ADDENDUM NUMBER TWO

Guste III Community Interior and Exterior Work Items

IFB No. 25-911-35

Questions and Answers

4 PLAN @ NEW DOOR OPENING
A-141 BALCONY DOOR SCALE: 1-1/2" = 1'-0"

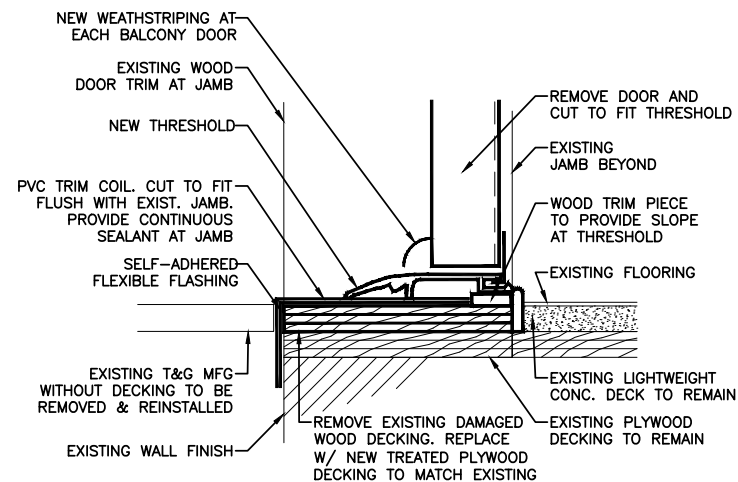
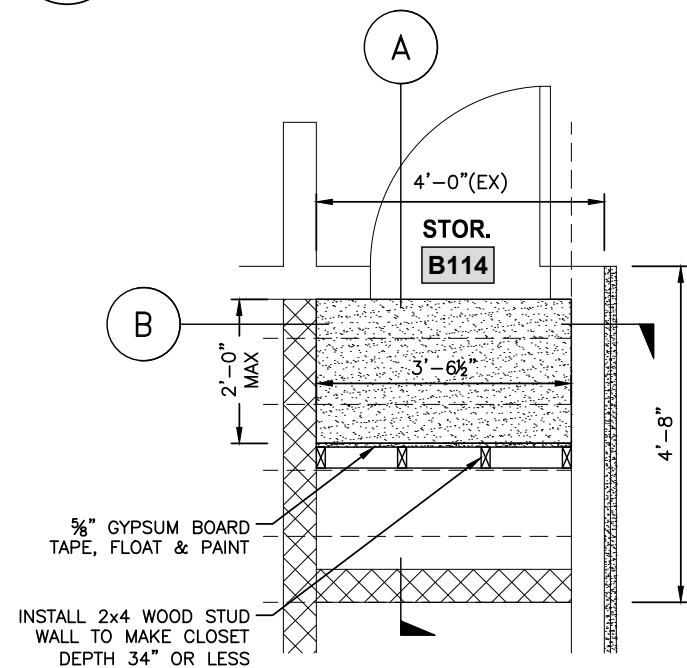
7. During the walkthrough Legacy requested additional information related to the door replacement required in Building M. Sheet The callout indicates that the door should be 3'- 6" for the new opening. Could you clarify if the actual door should 36" total which would eliminate modification to the masonry work on the doors.

Answer: The width of the new doors will be 36", and the revised sheet A-141 is issued with this addendum.
